**PSE&G** Public Service  
Electric and Gas  
Company

August 20, 1984

HOPE CREEK GENERATING STATION  
DOCKET NO. 50-354  
DRAFT SAFETY EVALUATION REPORT  
OPEN ITEM STATUS

Attachment 1 is a current list which provides a status of the open items identified in Section 1.7 of the Draft Safety Evaluation Report (SER). Items identified as "complete" are those for which PSE&G has provided responses and no confirmation of status has been received from the staff. We will consider these items closed unless notified otherwise. In order to permit timely resolution of items identified as "complete" which may not be resolved to the staff's satisfaction, please provide a specific description of the issue which remains to be resolved.

FIGURE ~~A11E12~~ 220.21-42  
 RESPONSE SPECTRA COMPARISON,  
 INTAKE STRUCTURE AT ELEV. 135'-0".  
 N-S, OBE, 2% DAMPING

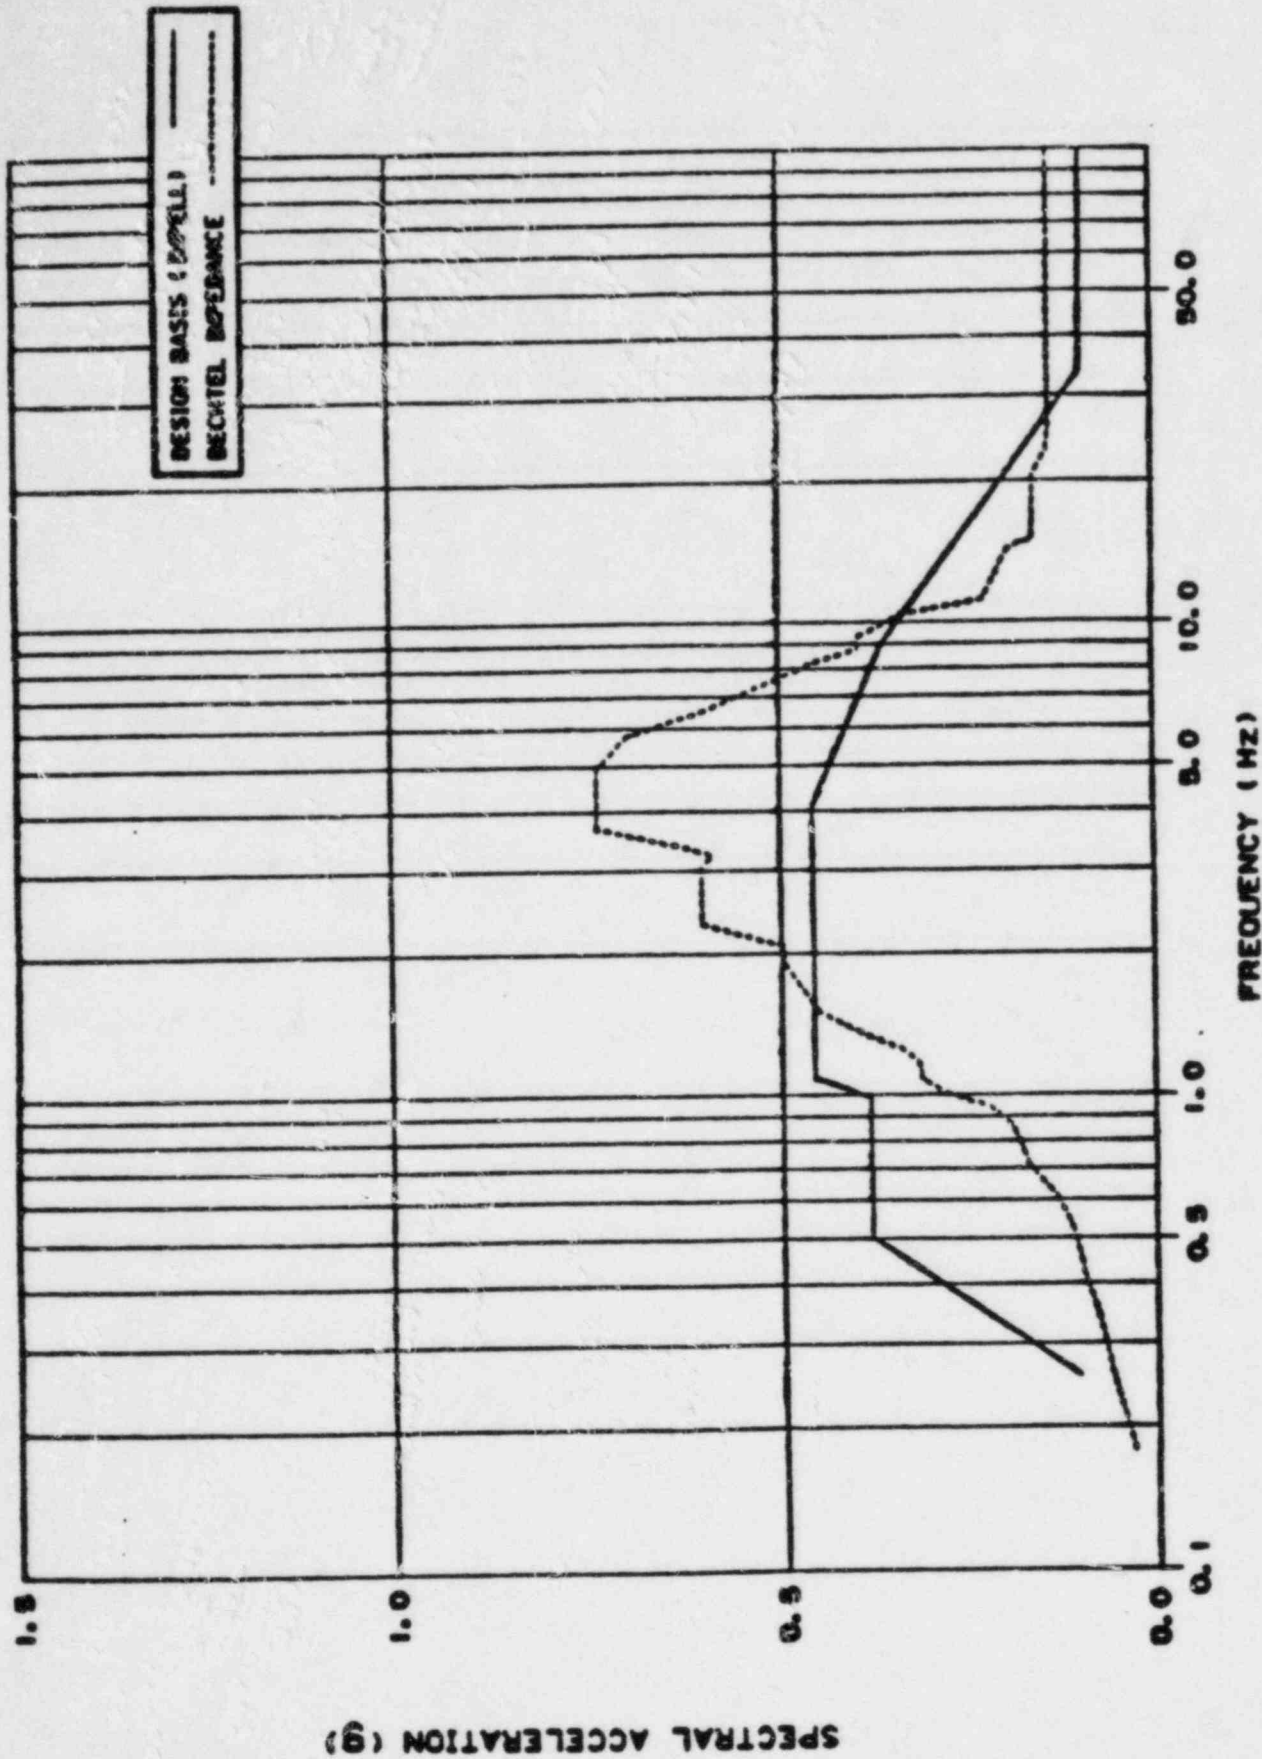
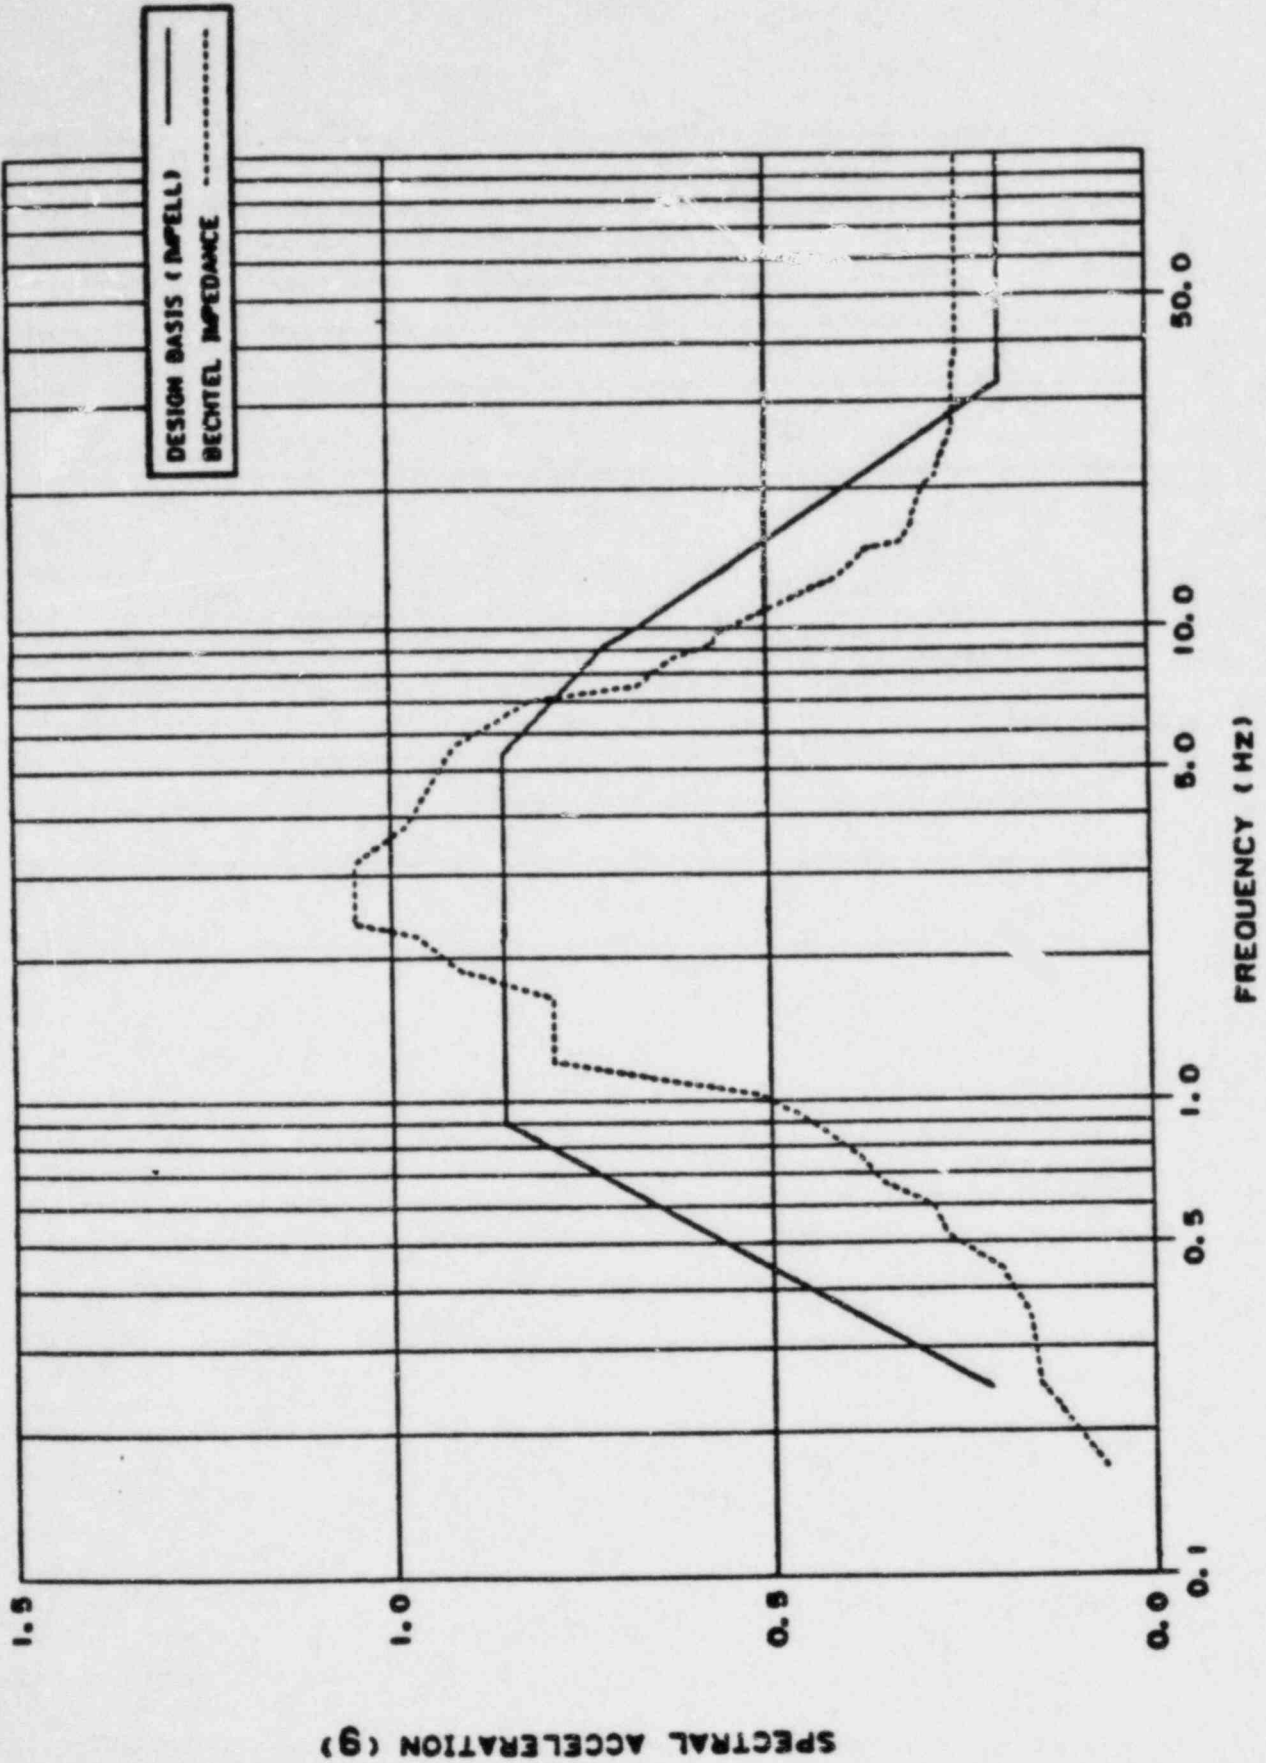
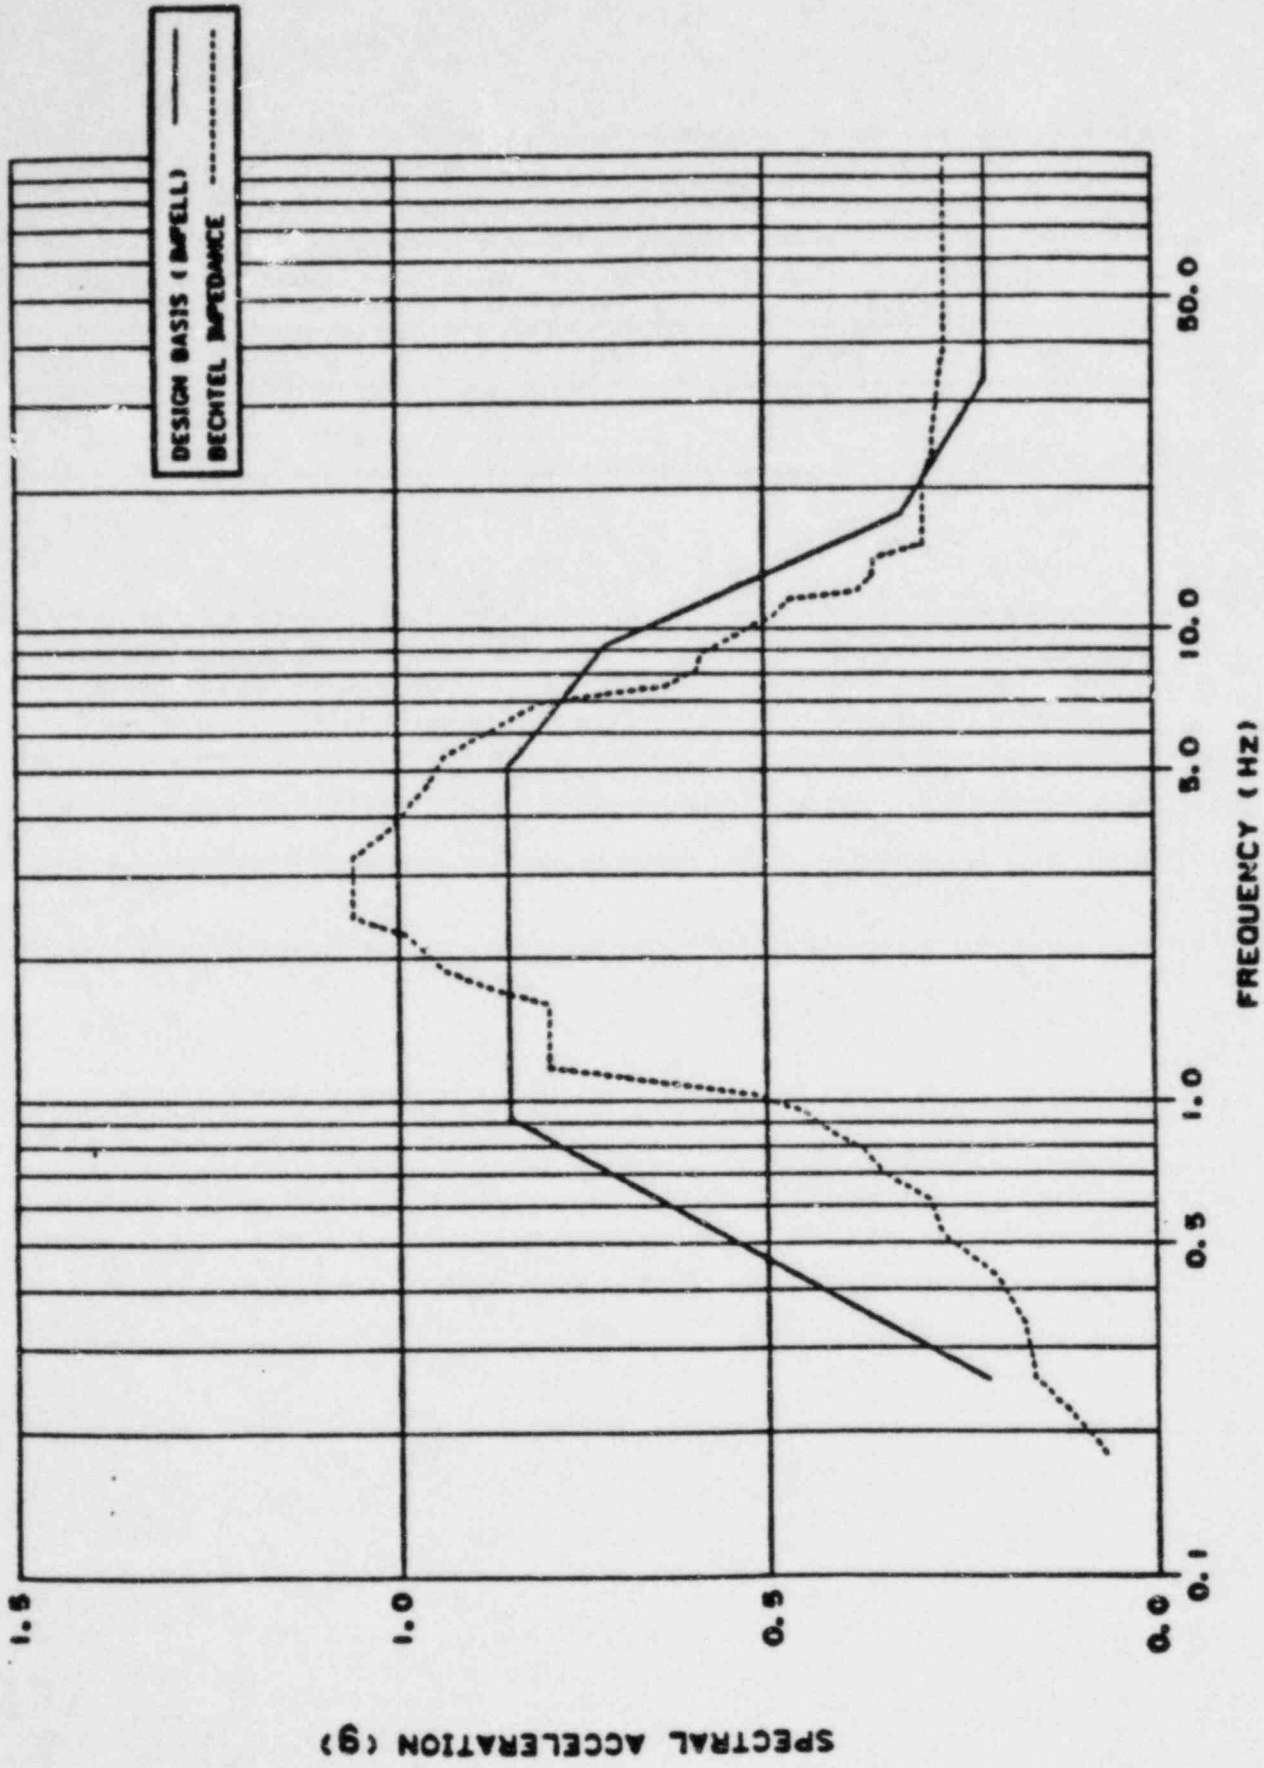
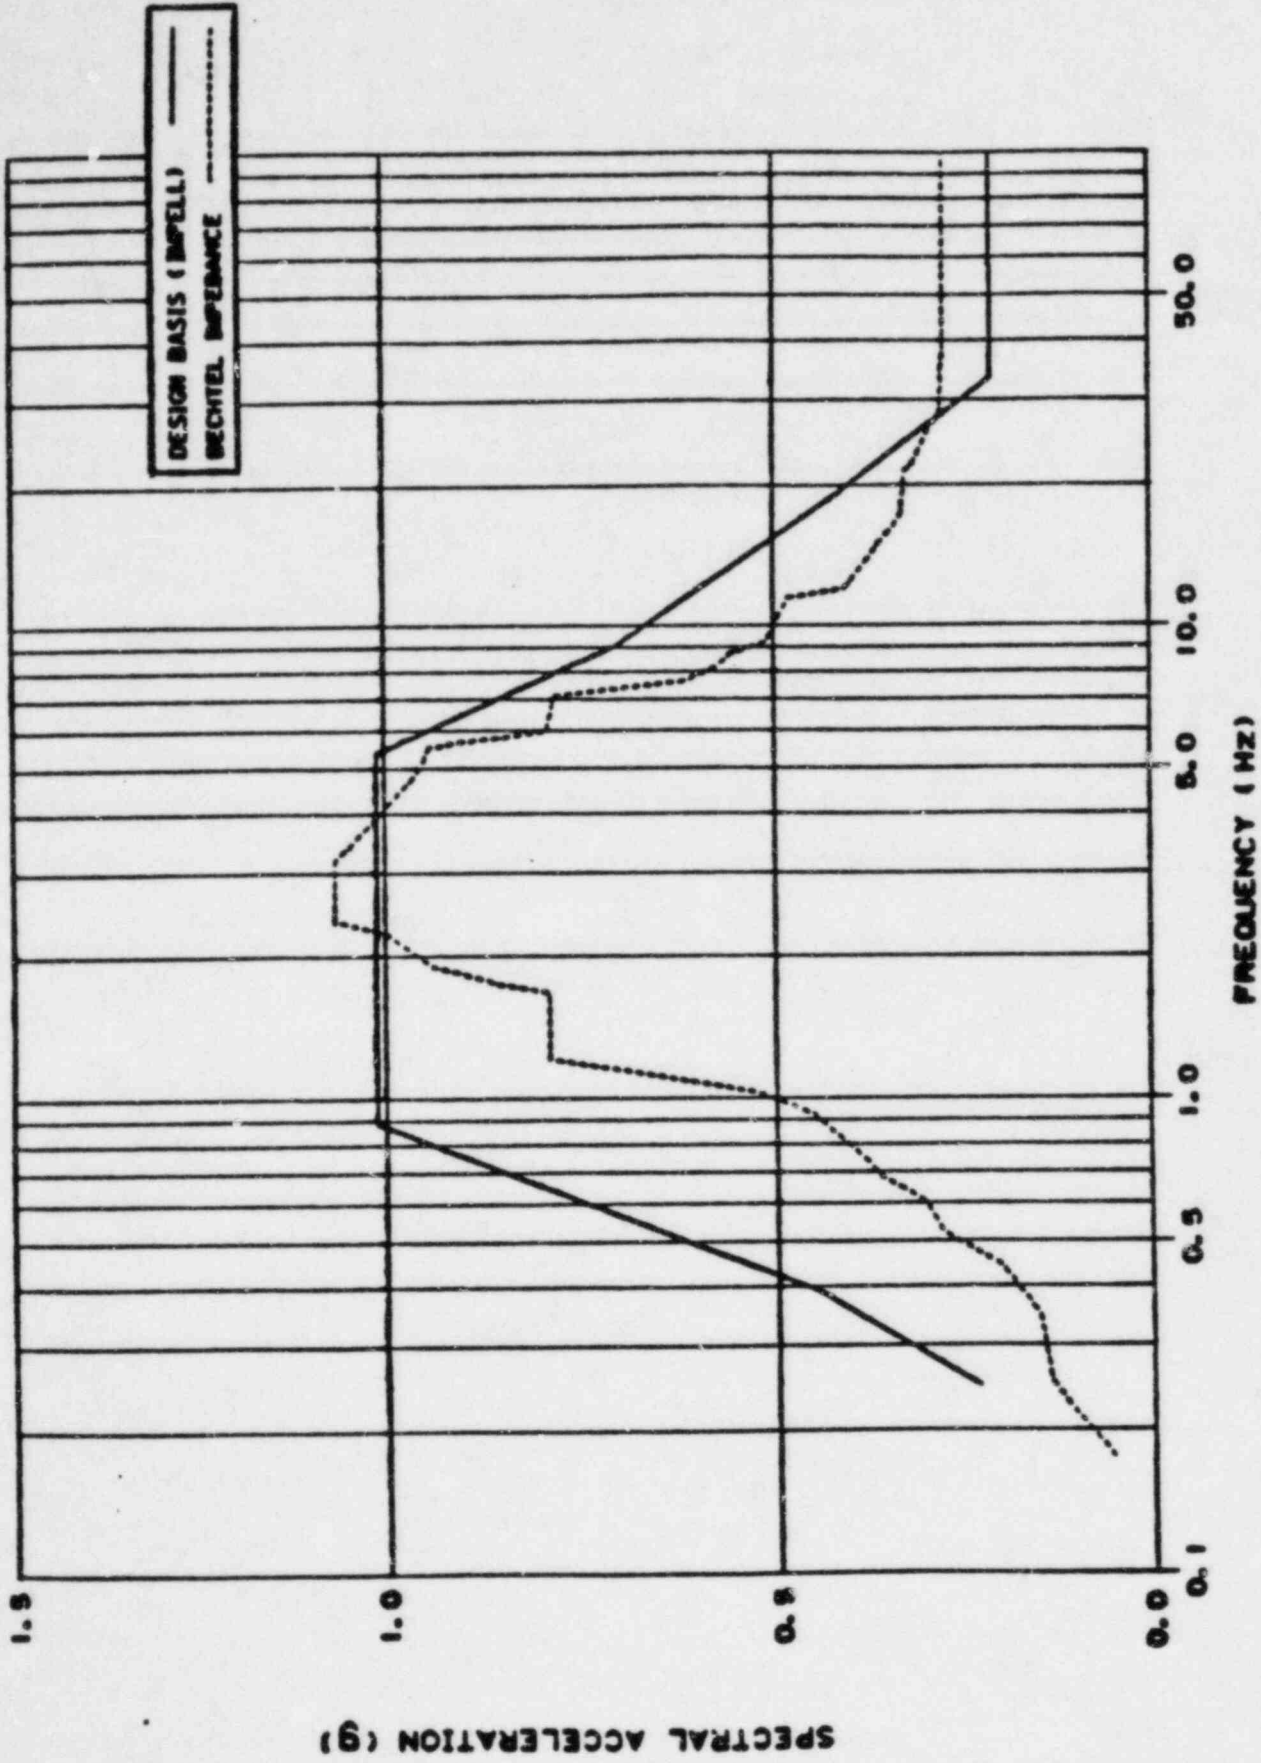
Figures 220.21-1 through 220.21-54 show a comparison of the 2 percent damping response spectra obtained from the design basis finite element and the impedance analyses for the reactor building, auxiliary building and the service water intake structure (SWIS).

¶ For the reactor and auxiliary buildings, the peak spectral accelerations obtained from the impedance analysis are generally lower than those obtained from the design basis analysis. However, the impedance analysis response spectra are not completely enveloped by those obtained from the design basis analysis, especially in the frequency range from 1.0 to 3.5 Hz. Also, there are some local exceedances in the higher frequency range, as shown in Figures 220.21-1 through 220.21-36. ¶ For the SWIS (Figures 220.21-37 through 220.21-54), the impedance analysis response spectra are generally enveloped by those obtained from the design basis analysis at elevation 114.0 feet. For other elevations, the impedance analysis spectral accelerations exceed the design basis spectral accelerations in some frequency ranges. These ranges vary approximately between 1.5 and 10.0 Hz.

In all cases, the items reviewed during these sampling studies can accommodate the loads resulting from the impedance analysis. Therefore, the impedance analysis results have no impact on the plant design.
